THE CORPORATION OF THE DISTRICT OF BURNABY

PLANNING DEPARTMENT

REZONING REFERENCE #63/69

SUBJECT: REZONING REFERENCE #63/69
LOTS 1 AND 2 W. $\frac{1}{2}$, BLOCK 13, D.L.158 E. $\frac{1}{2}$, PLAN 1908
PROPOSED C.D. SCHEME

COMMERCIAL LEVEL PLAN

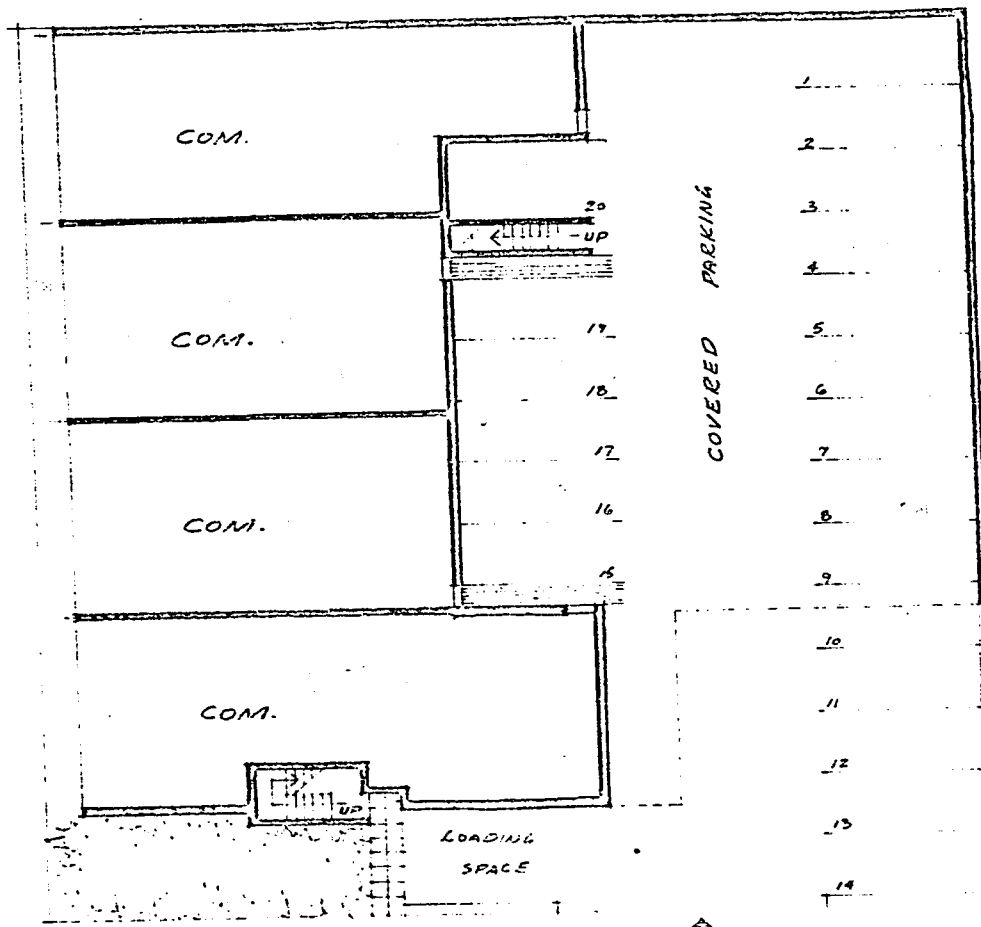
As noted in the Bylaw definition of usable open space, required front yards are excluded as part of the total required usable open space area. Therefore, the deck area which fronts on Neville Street, as noted on the applicant's submittal, could not be considered as complying with the requirements for developed usable open space. This would apply to the required 25-foot front yard setback for the apartment development along the entire frontage on Neville Street. The deck area over the proposed underground parking structure as noted on the Planning Department's proposal would comply with the regulations, i.e. the area is located behind the required front yard, its dimensions are greater than the 20' minimum, and it is available for use by all the tenants (see area outlined in red on attached plans).
